**RE: U-Haul
8200 Jefferson Street NE
Conceptual Grading and Drainage Plans
Engineer's Stamp Date: No Stamp Date
Hydrology File: C17D146**

Thank you for taking the time to review the Conceptual Grading and Drainage plan for the proposed U-Haul development at 8200 Jefferson Street NE. We have received the city's review comments dated January 29, 2024 and have prepared the following information to address your review comments. Please note that for your convenience each review item is restated below along with our corresponding response.

| CHECKED: | ARA | GD-2 |

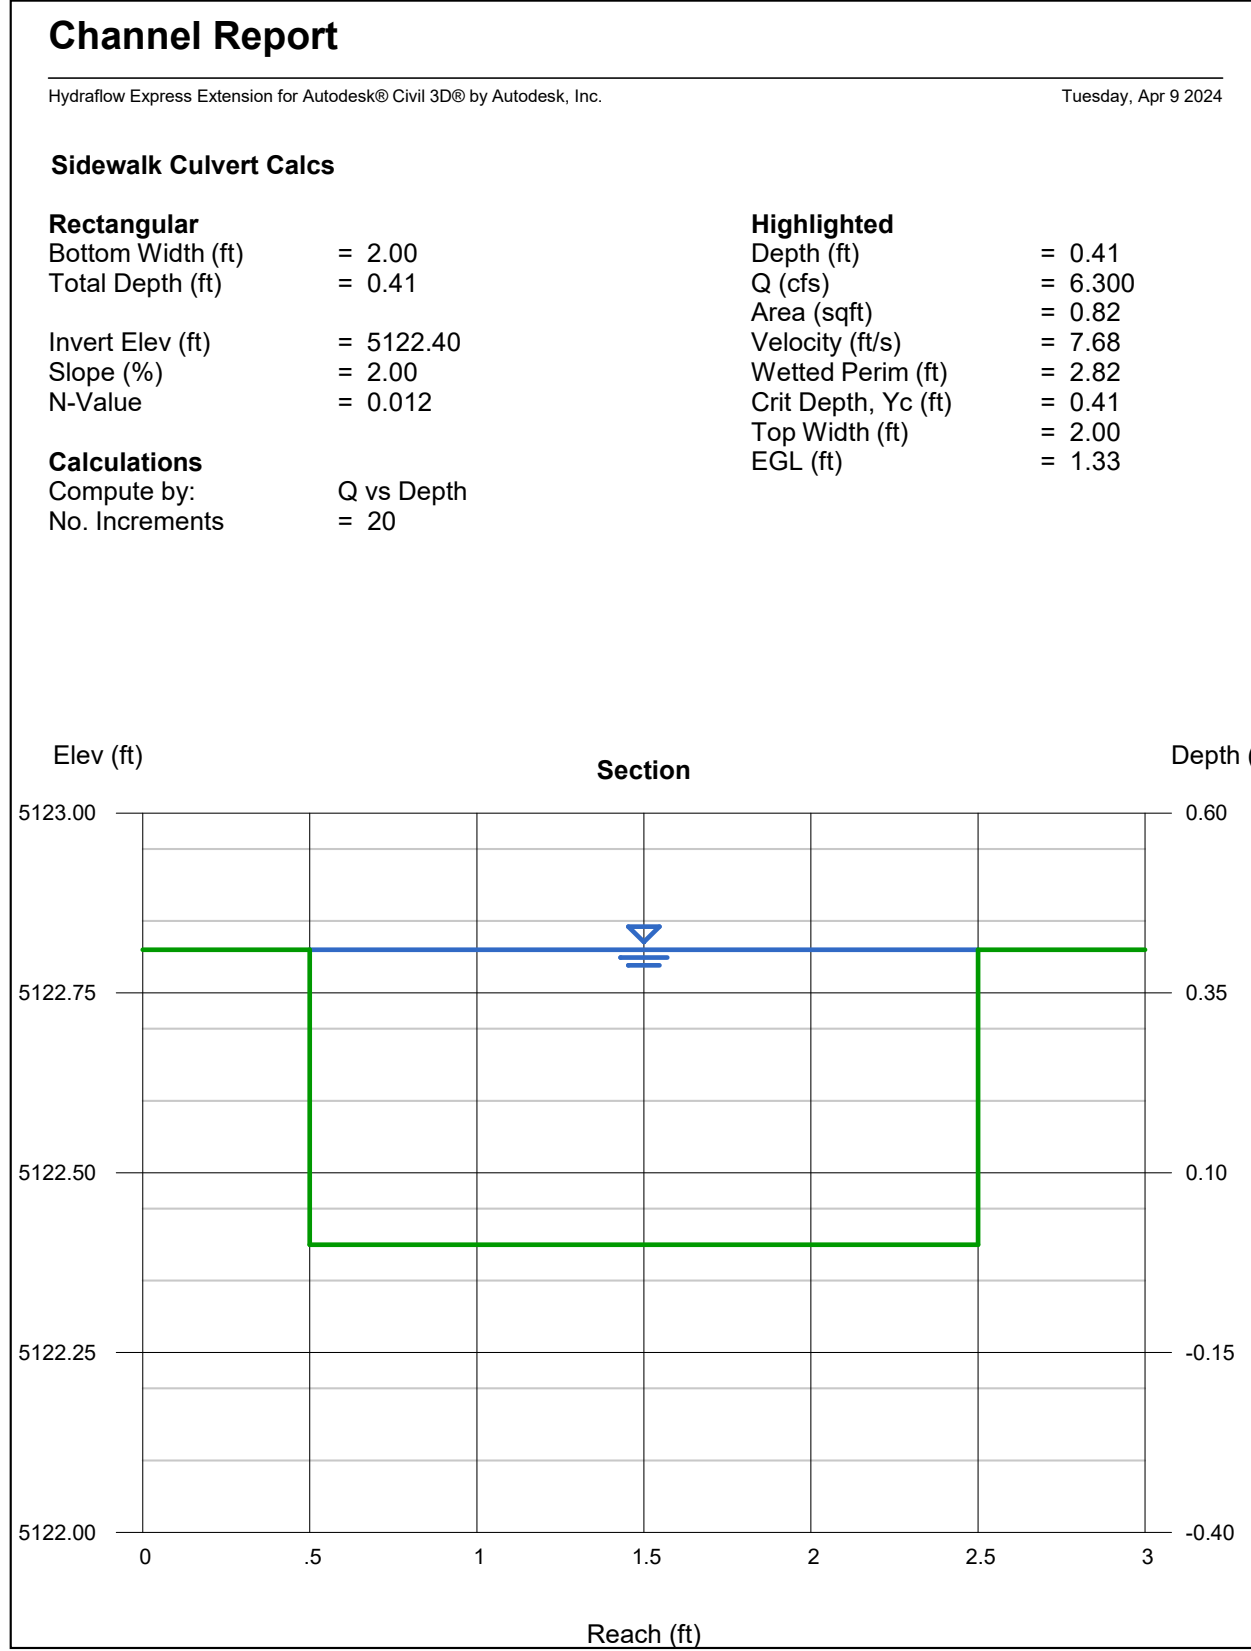
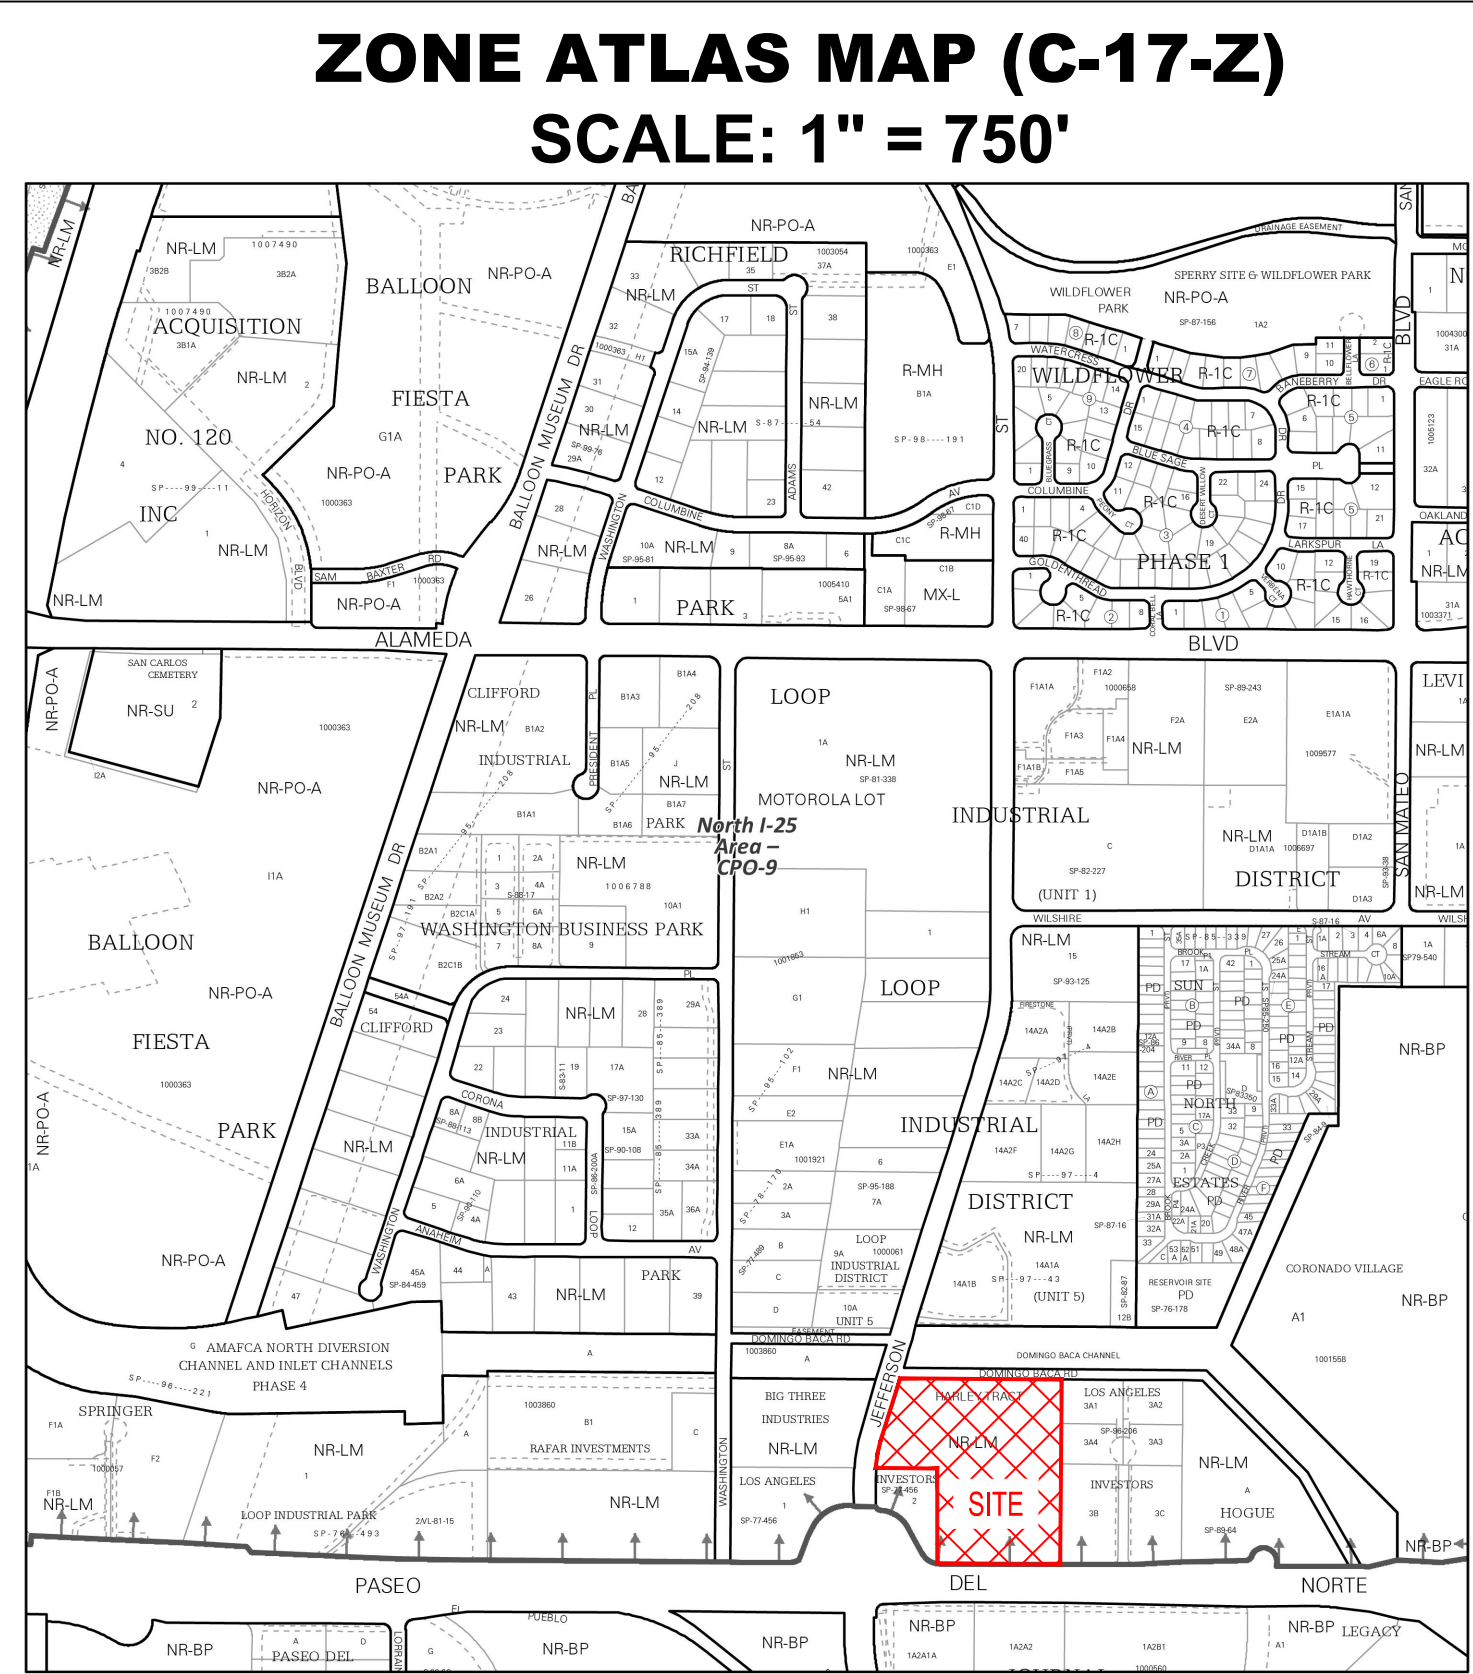
I have no further comments on this plan. The pond labeling was all I needed and they have sufficient capacity.

The NW pond has 37,398 CF of volume and is shown on sheet 2 of the attachment. The SW ponds have volumes of 1,059 CF and 1,200 CF. These three ponds combine to have over four (4) times the required volume by the City of Albuquerque standards.

City of Albuquerque
Planning Department
Development Review Services
PRELIMINARY APPROVED
DATE: 05/21/24
BY: *Rosie C. Brucette*
HydroTrans #: C17D146
THESE PLANS AND/OR REPORT ARE
CONCEPTUAL ONLY. MORE INFORMATION MAY
BE NEEDED IN THEM AND SUBMITTED TO
HYDROLOGY FOR BUILDING PERMIT APPROVAL.

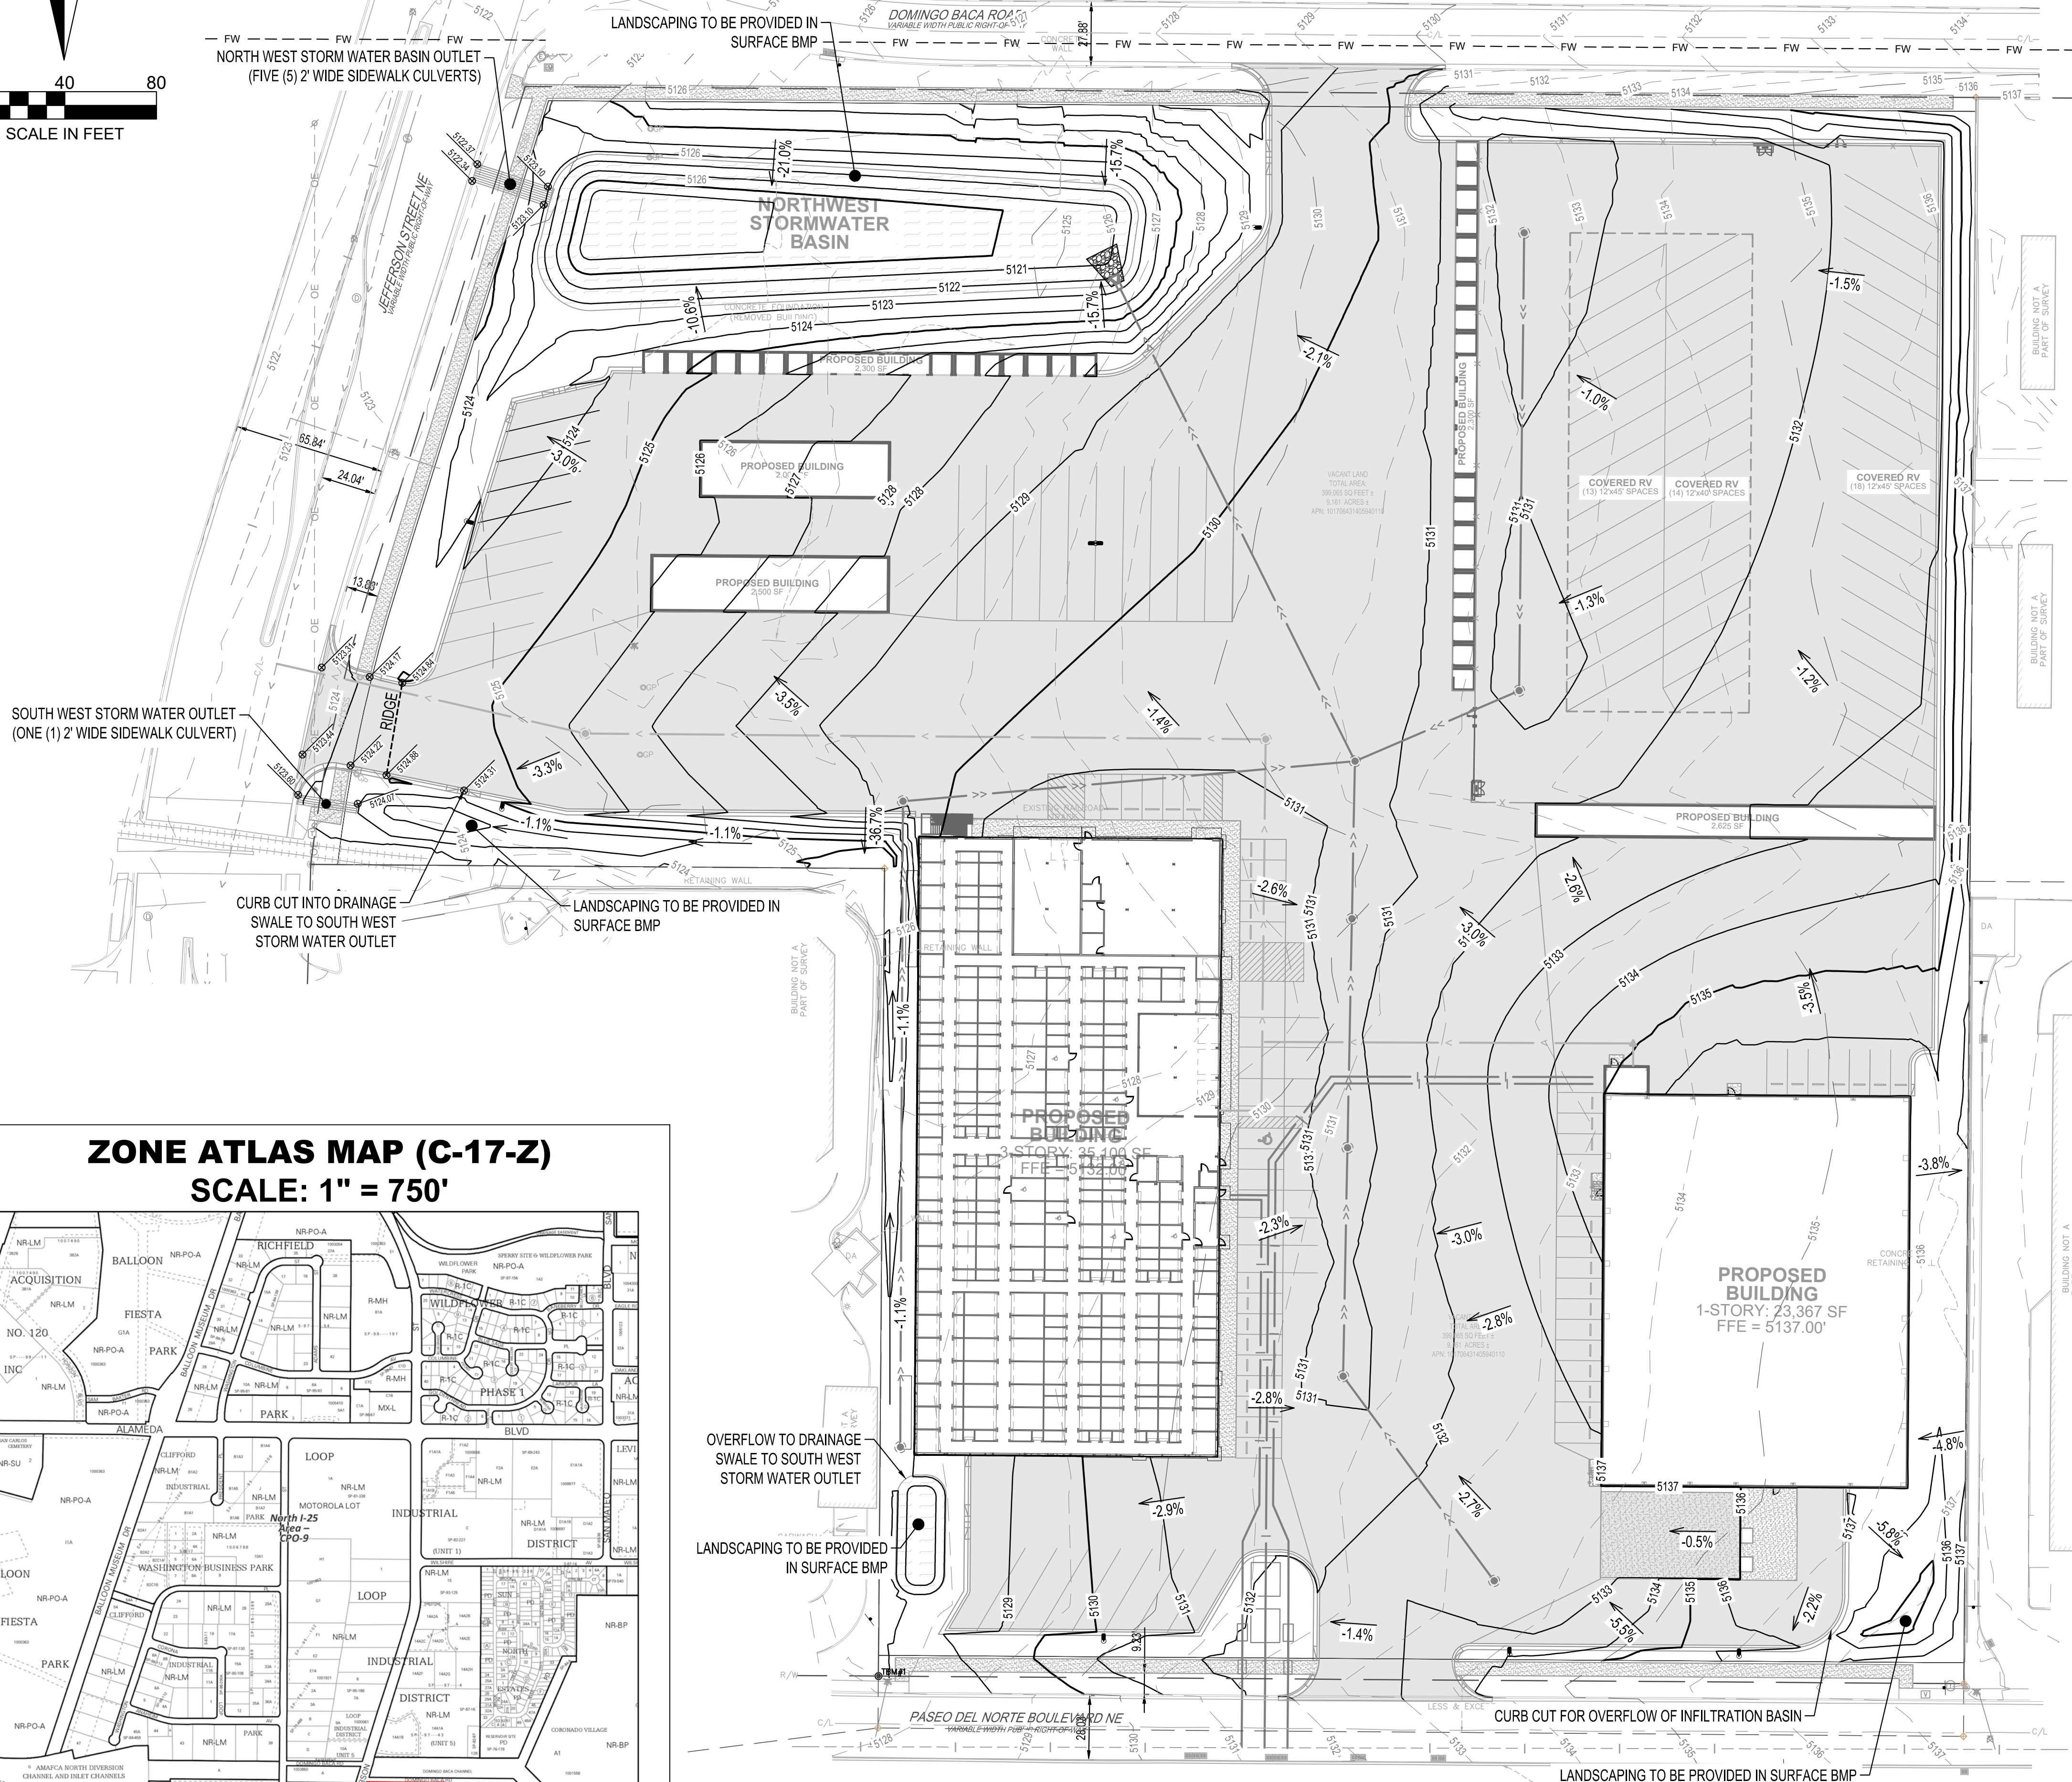
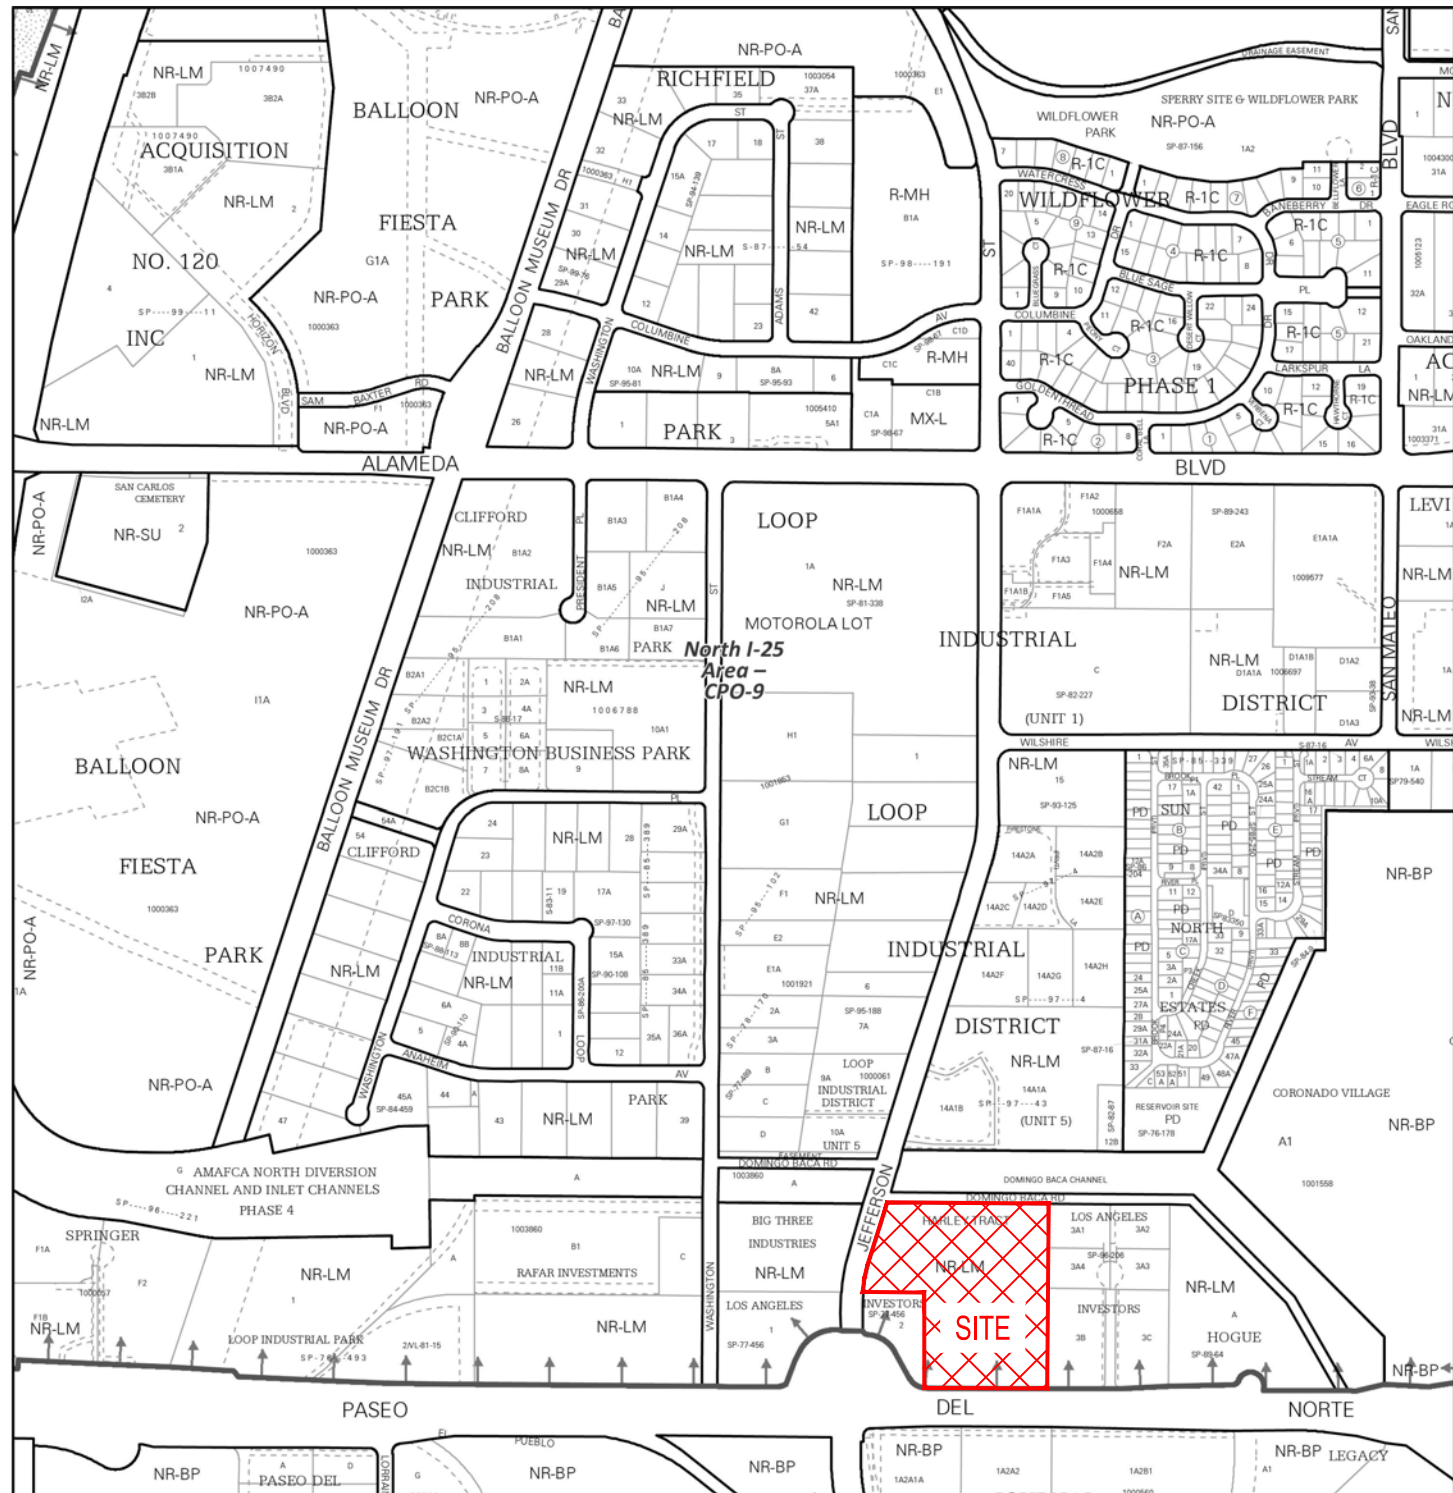
PO Box 1293
Based upon the information provided in your submittal received 05/14/2024, the Conceptual Grading & Drainage Plans are preliminary approved for action by the Development Facilitation Team (DFT) on Site Plan for Building Permit.

NM 87103
1. Please submit a more detailed Grading & Drainage Plan to Hydrology for review and approval. This digital (.pdf) is emailed to PLNDRS@cabq.gov along with the Drainage Transportation Information Sheet.
